| APPLICATION NO.   | FILING DATE | FIRST NAMED INVENTOR | ATTORNEY DOCKET NO.            | CONFIRMATION NO.       |
|---|-------------|----------------------|--------------------------------|------------------------|
| 10/510,039  | 04/13/2005  | Erich Fuderer        | 566/42762                      | 4659                   |

## Office Action Summary

**DETAILED ACTION*****Drawings***

FIG. 1

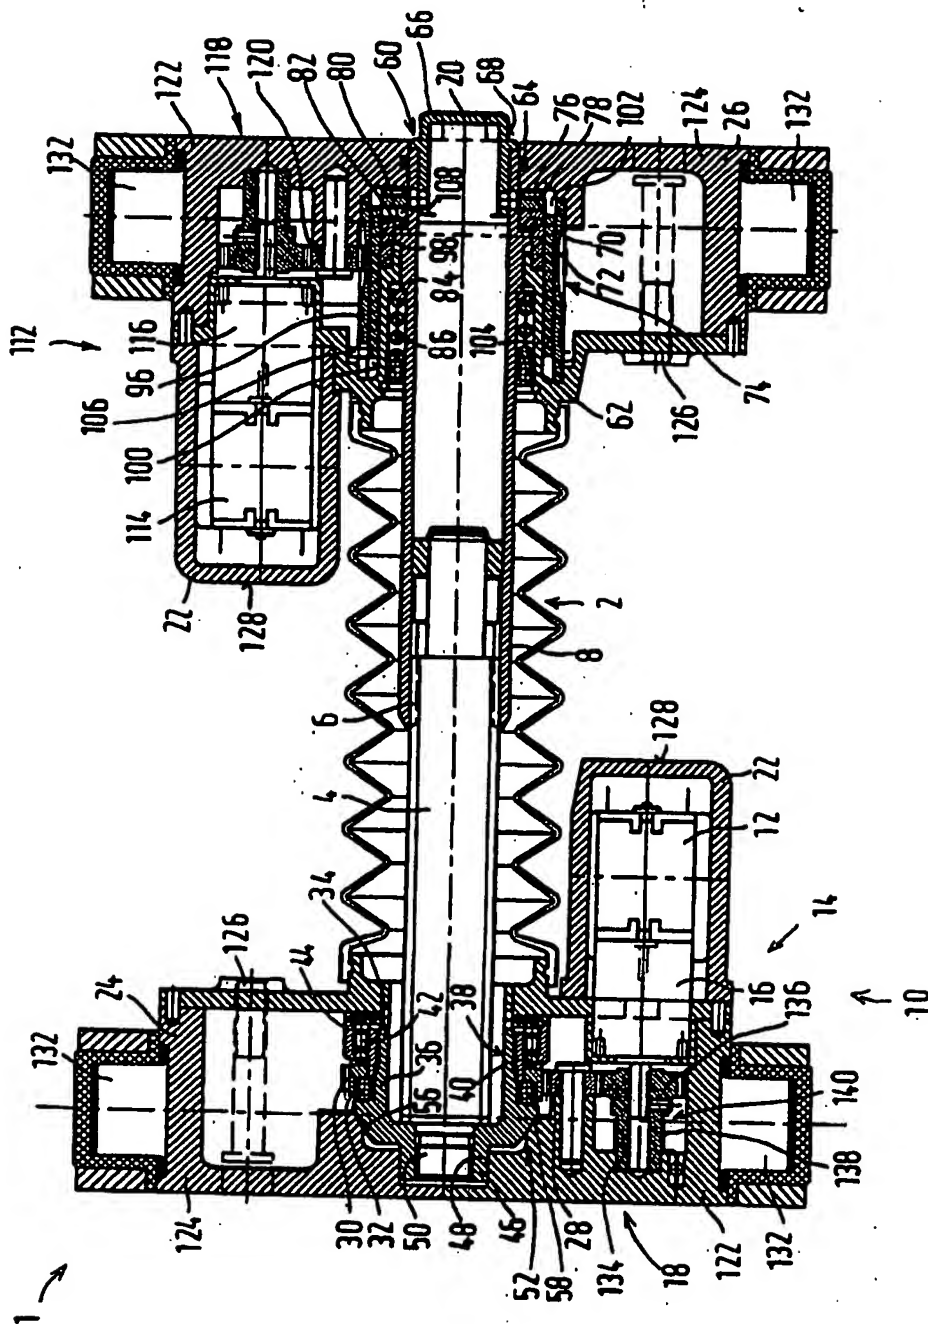
3. The drawings were received on 4/3/07. These drawings are not approved. Figures 1 and 2 are not approved because they are of poorer quality than figures 1 and 2, which are already in the file. Figure 3 is not approved because of hand written notes and there is no clear showing of contrate gearing 80 and 82. Figure 4 is not approved because of hand written notes and there is no clear showing of balls 40 and clutch 38. Furthermore, figures 3 and 4 are not exploded views. They are simply enlargements of figures 1 and 2. Because of these reason, the drawing objections are repeated above.

NOT approved  
xw  
5/24/07

NOT approved  
5/24/07  
XLN

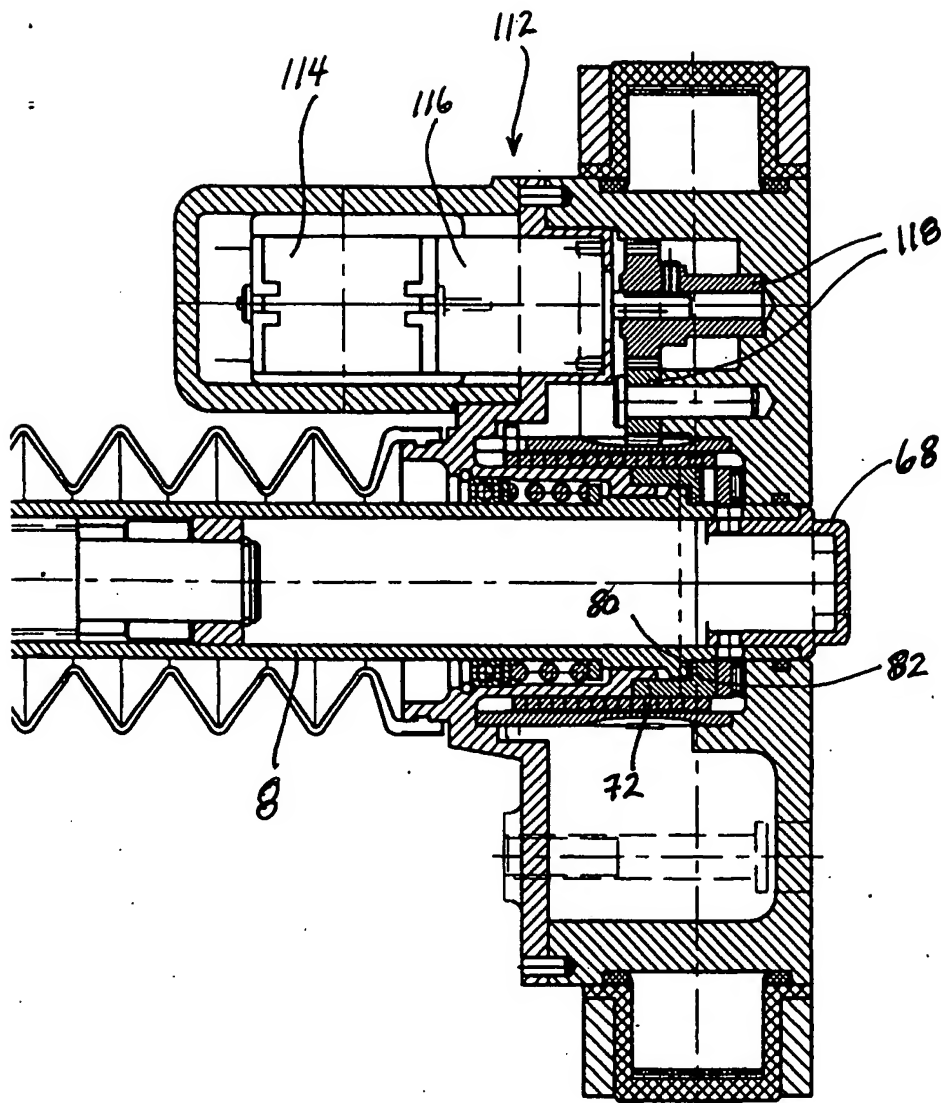
NOT approved  
XLN  
5/24/07

FIG. 3

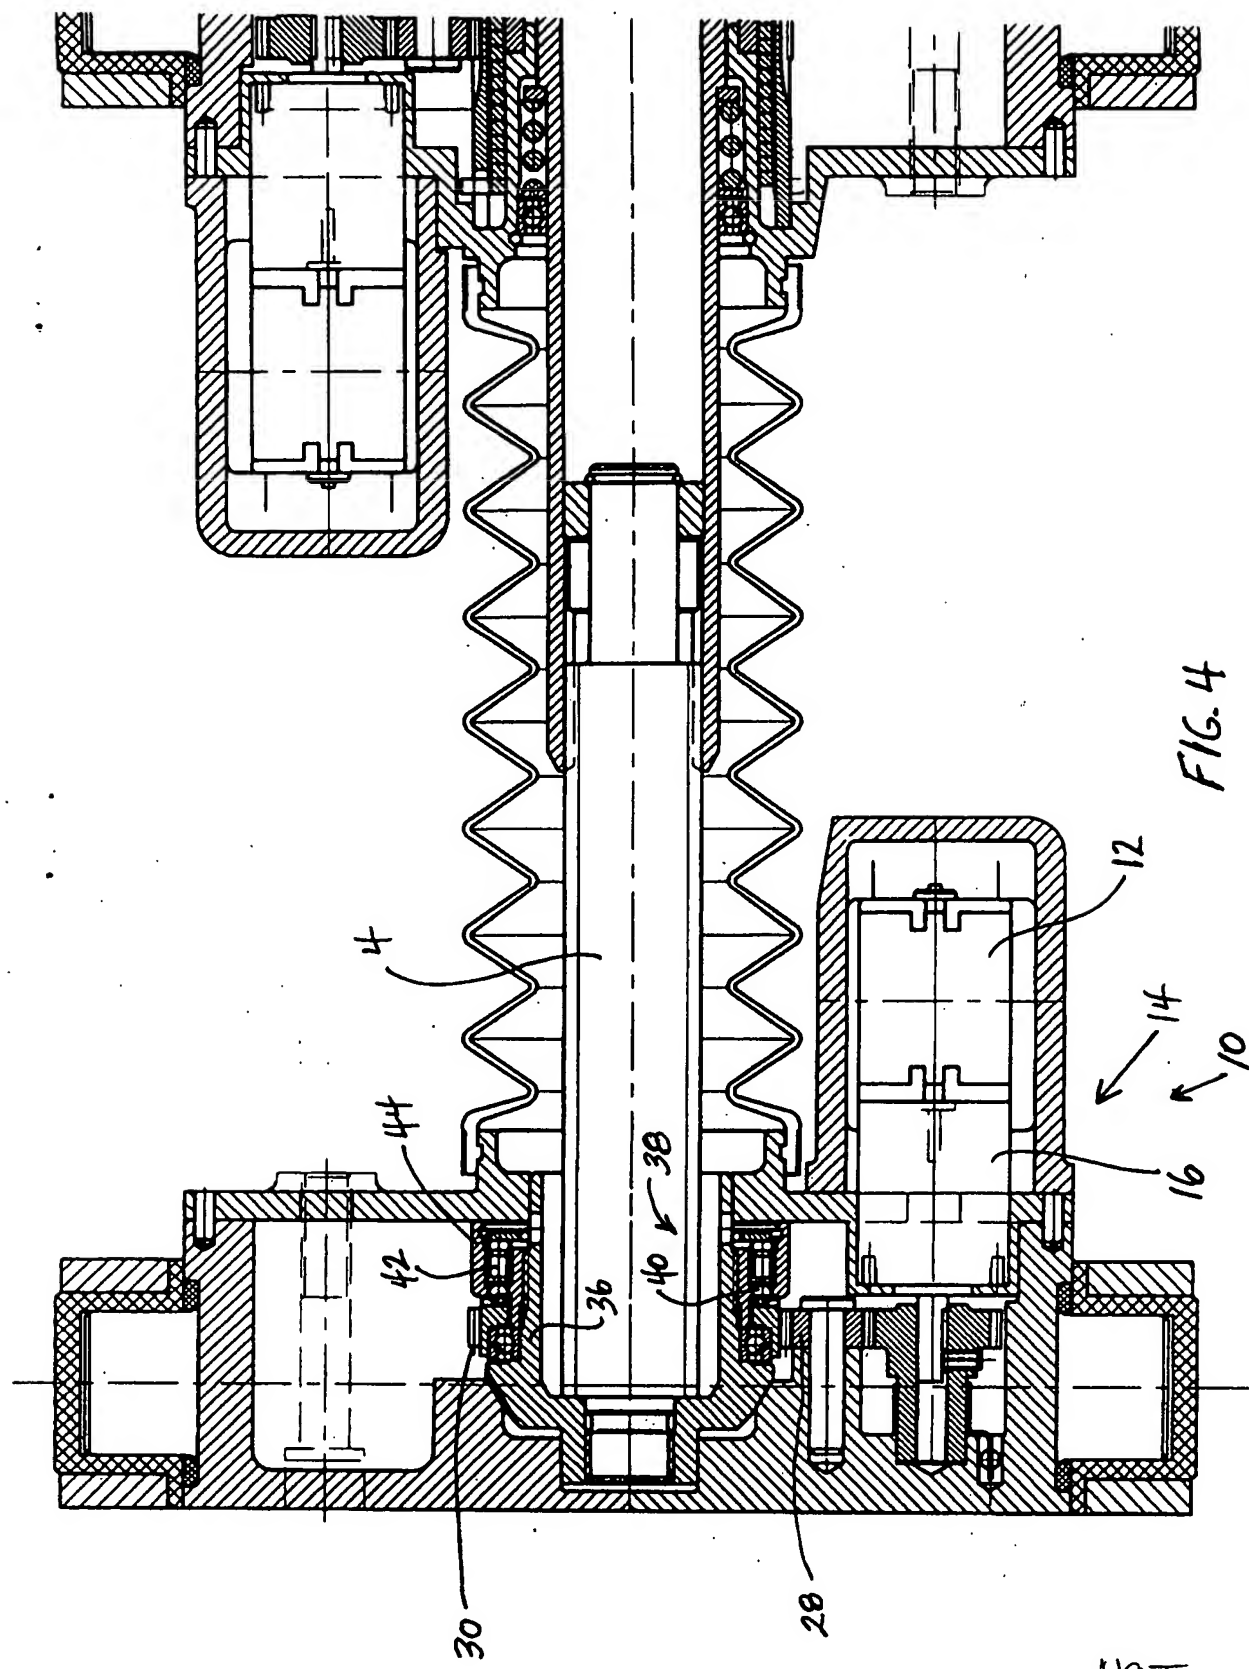
NOT approved  
XLN  
5/24/07

1. The drawings are objected to under 37 CFR 1.83(a) because they fail to show the gearings and slip clutch of the emergency release device and the gearings and clutch of the wear adjuster as described in the specification. Details drawings of these components are needed; since presently, the details are small and hard to distinguish from surrounding components. Because of the deficiencies, it is hard to understand the detailed structures of the instant invention as described and claimed. Any structural detail that is essential for a proper understanding of the disclosed invention should be shown in the drawing. MPEP § 608.02(d). Corrected drawing sheets in compliance with 37 CFR 1.121(d) are required in reply to the Office action to avoid abandonment of the application. Any amended replacement drawing sheet should include all of the figures appearing on the immediate prior version of the sheet, even if only one figure is being amended. The figure or figure number of an amended drawing should not be labeled as "amended." If a drawing figure is to be canceled, the appropriate figure must be removed from the replacement sheet, and where necessary, the remaining figures must be renumbered and appropriate changes made to the brief description of the several views of the drawings for consistency. Additional replacement sheets may be necessary to show the renumbering of the remaining figures. Each drawing sheet submitted after the filing date of an application must be labeled in the top margin as either "Replacement Sheet" or "New Sheet" pursuant to 37 CFR 1.121(d). If the changes are
